ADDENDUM NO.: 2.0

DATE OF ADDENDUM: May 13, 2015

**Campus Site Improvements  
Naugatuck Valley Community College, Waterbury, Connecticut  
BI – CTC – 436**

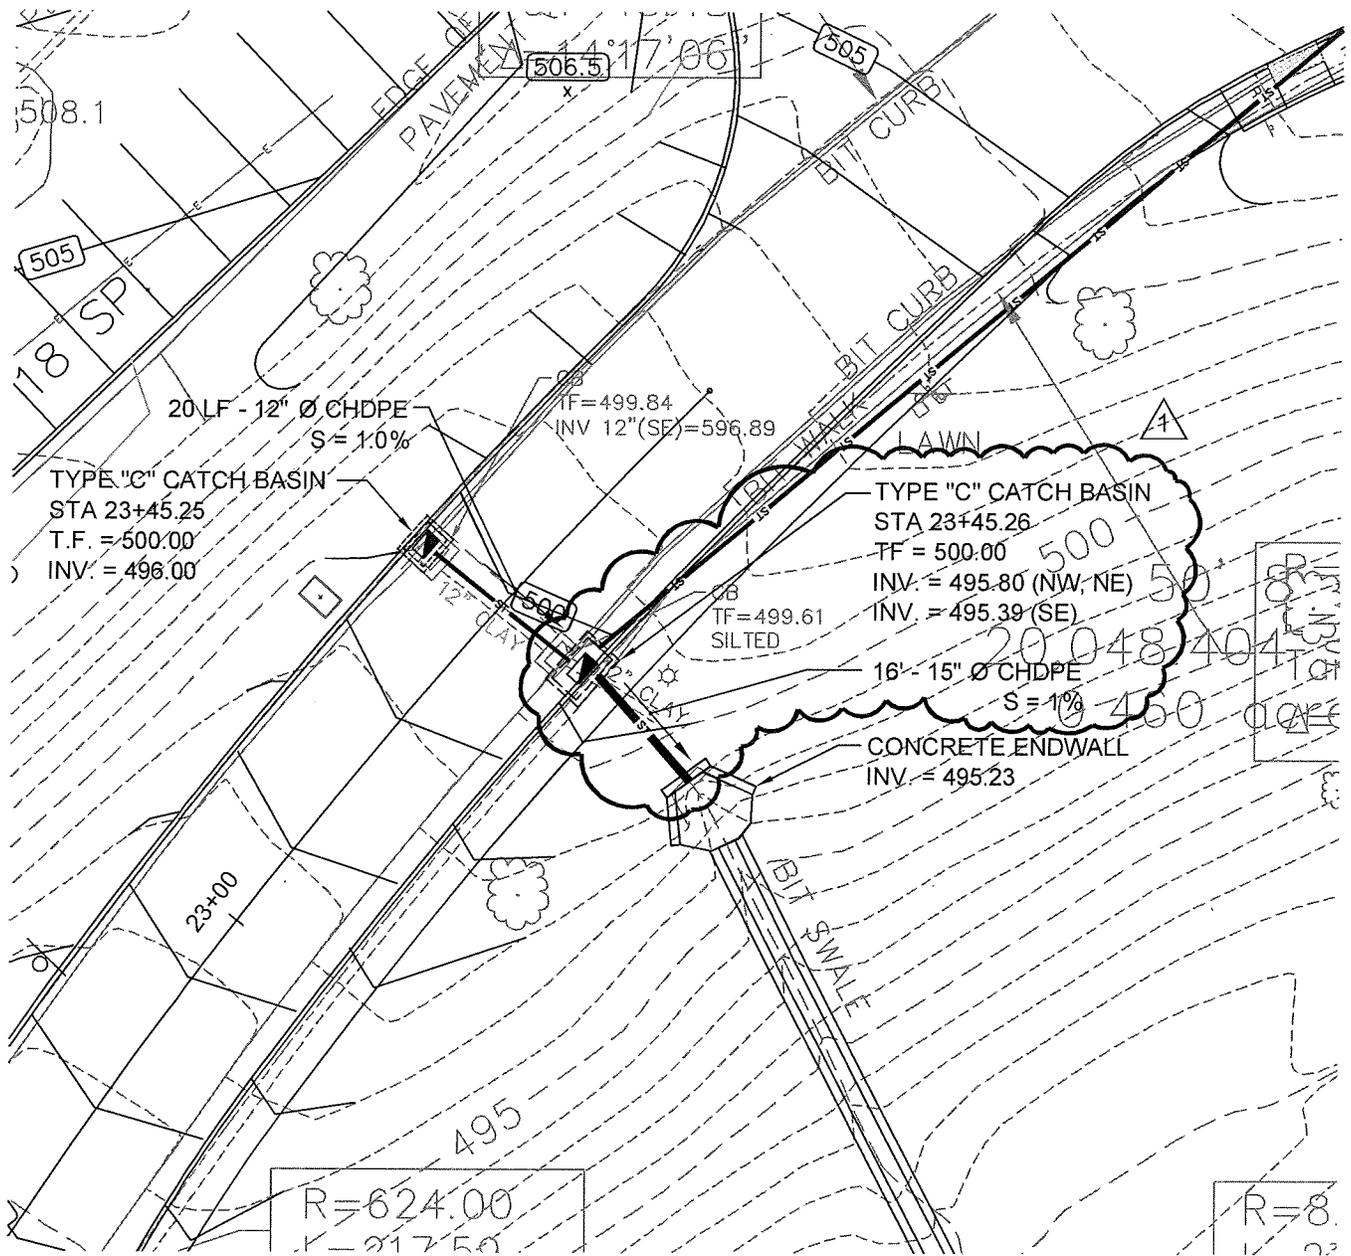
Before we work up prices to quote to contractors who may contact us for prices, I want to be sure I have the most complete up to date spec. Can we get a copy of the desired specification? Thank you for your help.

**Answer:** See the marked up Bus Shelter design guide attached to this addendum for details.

**SKETCH NO.**  
**AD1-SK-C5.3-1**

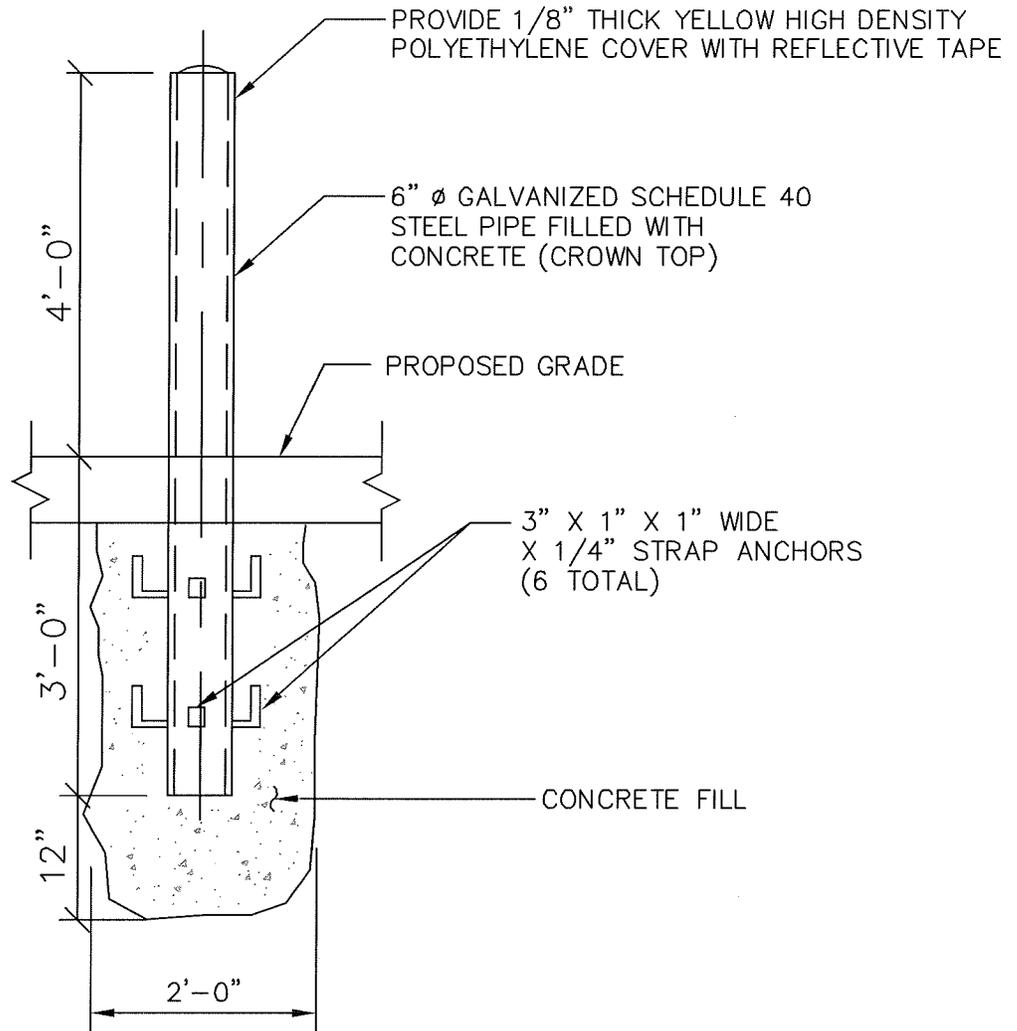
Drawing C5.3, Drainage structure on the right side of station 23+50 is designated as A Type A Catch basin with Sediment Chamber.

There is no detail included in the bid documents for that type of structure, please Provide a detail for this type of drainage structure.

**Answer:** We will eliminate this structure. It will obviously extend the length of the 15" pipe by 4'-0" +/- . We have checked the incoming inverts and they are higher, so no adjustment necessary at the CB itself.  
DRAWING C5.3 – REPLACE the storm drainage work associated with the Type A Catch Basin located at Station 23+45.26 RT as shown in AD1-SK-C5.3-1.

SKETCH NO.  
**AD2-SK-C6.2-1**

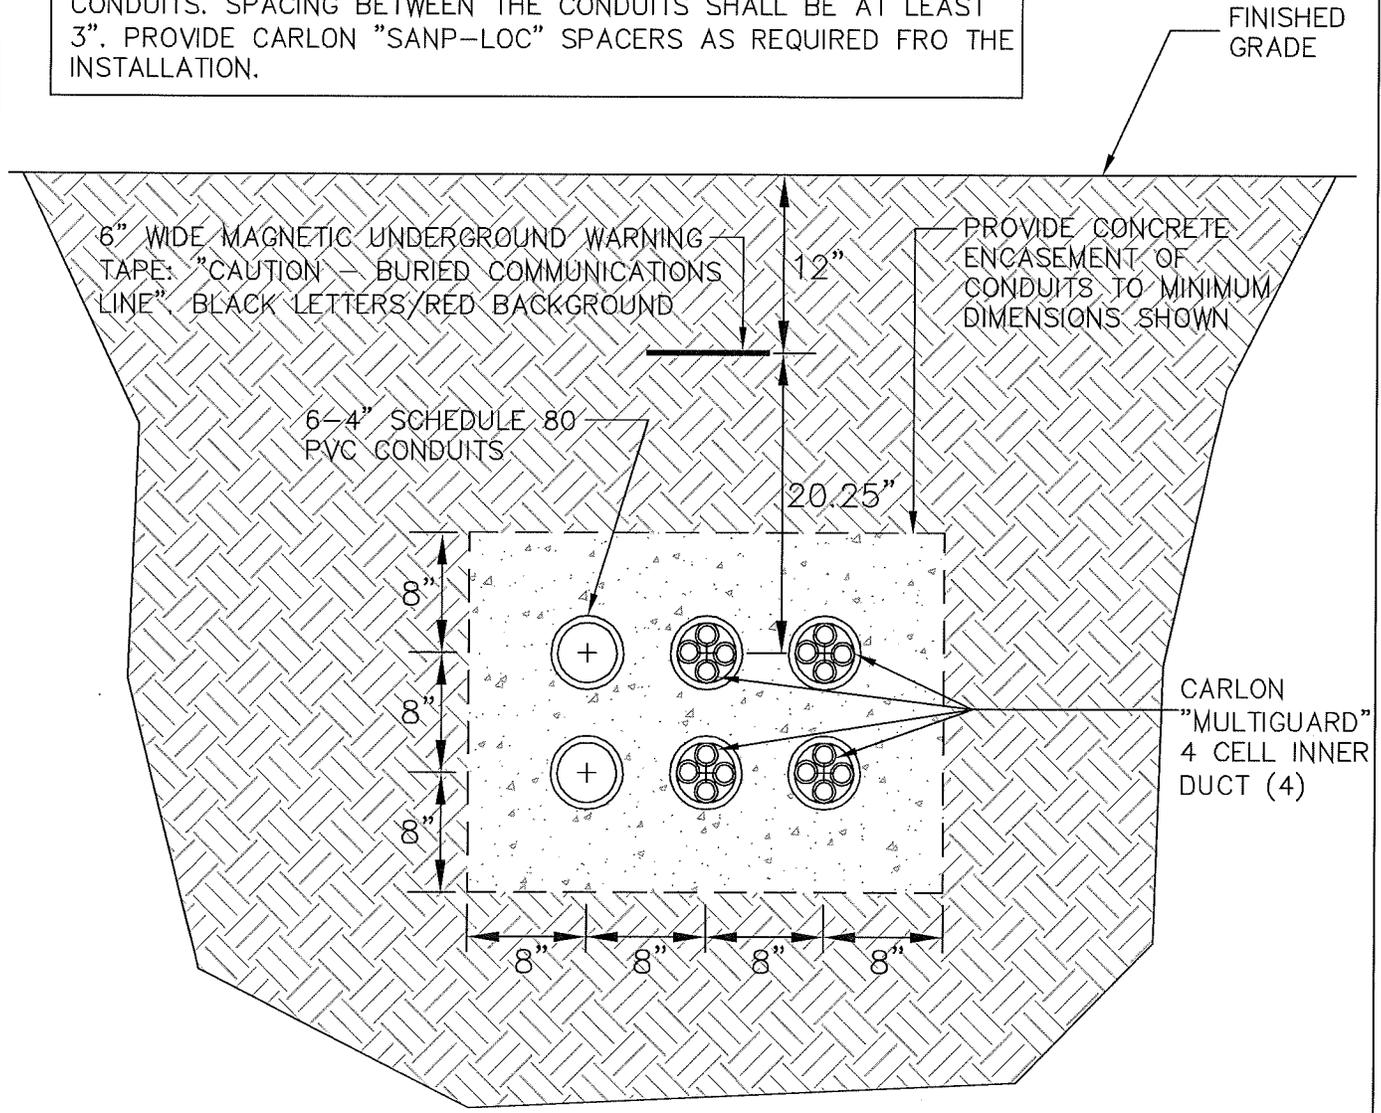
I cannot find the proposed bollards on the plans. Help!

**Answer:** See sheet C3.2 there are bollards at the relocated hydrant near lot G, include (4) four new at this location. Also include (6) six additional bollards to be located at the direction of the Morganti Group.

**Answer:** BP#1 owns the bollard work, also see additional information noted herein.
